Queens Community Board 11

July 20, 2017

RE: Bicycle Lane Plan

Computations For NB CIP Made By BH Date 7/15/17 Job No. _____
ENTRANCE RAMP Checked By _____ Date _____ Sec. No. _____
Back Checked By _____ Date _____ Sheet No. _____

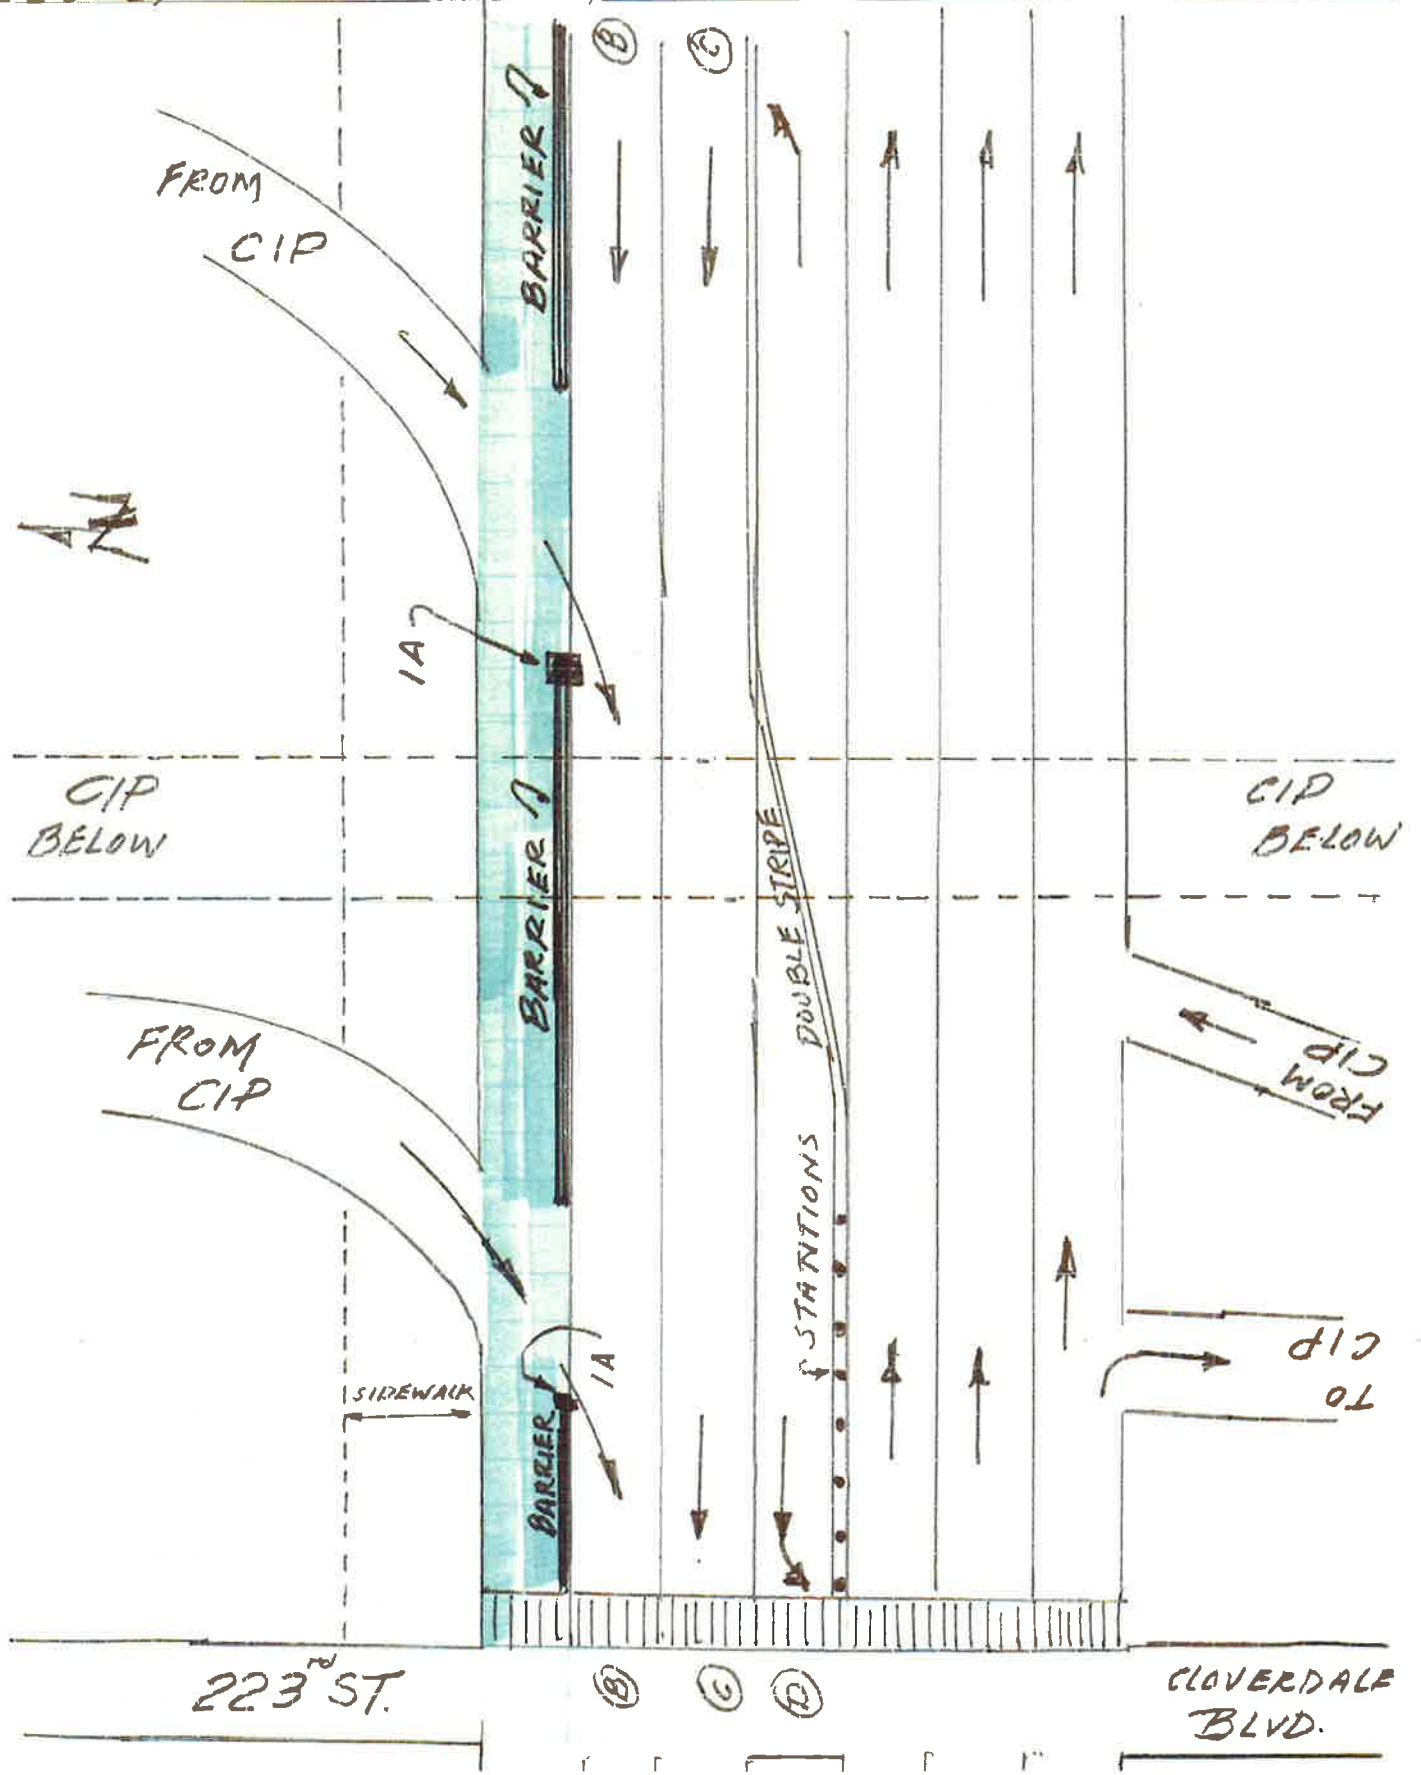
1) Most critical is DOT's extremely dangerous proposal to carry the bicycle lane past the entry and exit points of the three ramp intersections where vehicles are turning either into or out of a Cross Island Parkway (CIP) ramp. Only the northbound CIP entry ramp is signalized. The red signal stops vehicles turning north bound for a short period but when

green, drivers enter the ramp at 25 to 30 mph. Cyclists who are at the same pavement grade as the vehicles have no barrier protection. This is terribly dangerous with cyclists coming from two directions. Who has the right-of way (ROW)? At the two CIP exit ramps, drivers are looking over their shoulder to the left while accelerating into a clear space and can't simultaneously see the cyclist approaching from the right. This design will produce many injuries and possible fatalities. One solution is to stop the bicycle lane at Joe Michael's Mile and avoid the CIP ramps.

Computations For BRIDGE Made By BA Date 7/19/17 Job No. _____
OVER ALLEY CREEK Checked By NO SCALE Date _____ Sec. No. _____
 Back Checked By _____ Date _____ Sheet No. _____

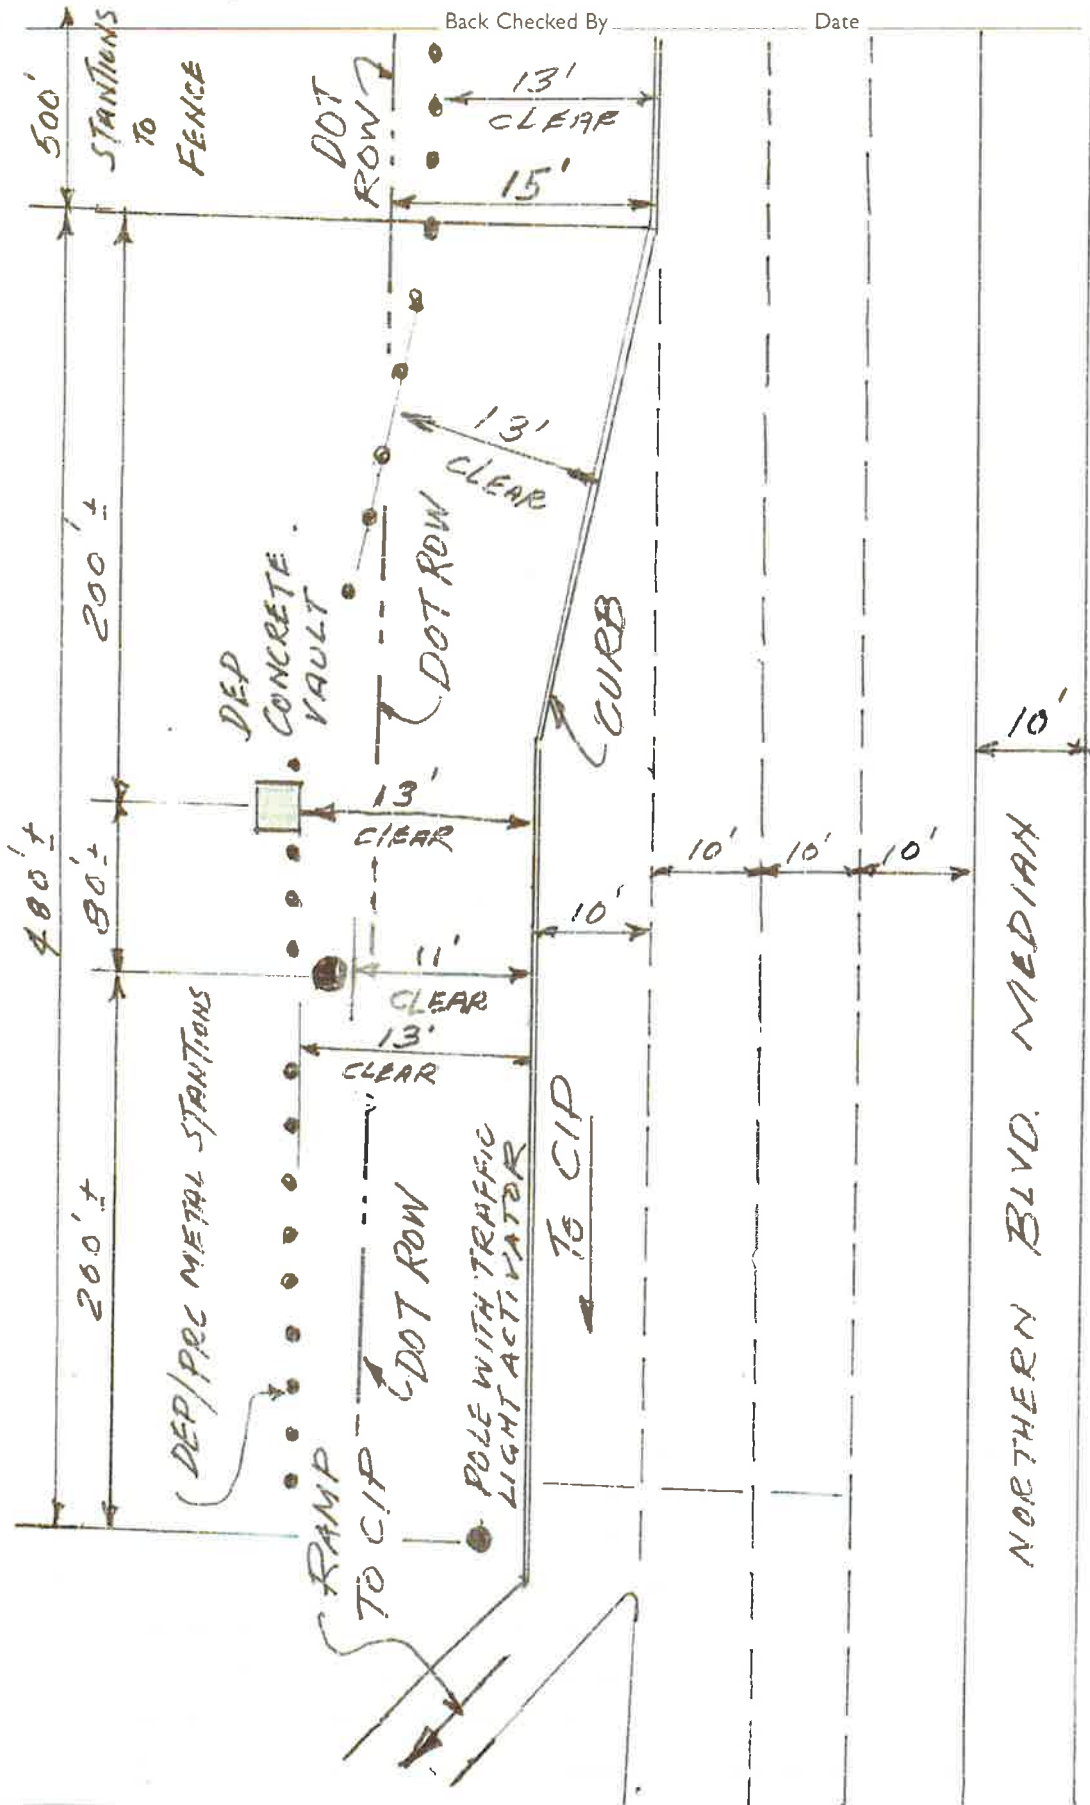
- a) Move the two light poles on the bridge, east and west for additional clearance to seven ft. (Estimated cost = \$15,000 -20,000. The move is about three to four ft. east and west.)
- b) DEP vault reduces clearance to 9 ft. + 4 ft. buffer. Can't be moved.
- c) Utility pole reduces clearance to 7 ft. + 4 ft. buffer. Can't be moved.

1) Widen bridge sidewalk three ft., from seven to 10 ft. Reduce median by three ft. for the 260' +/- bridge length. Stripe the westbound lanes to a smooth transition geometrically on both sides of the bridge. Estimated cost = \$30,000. +/-.
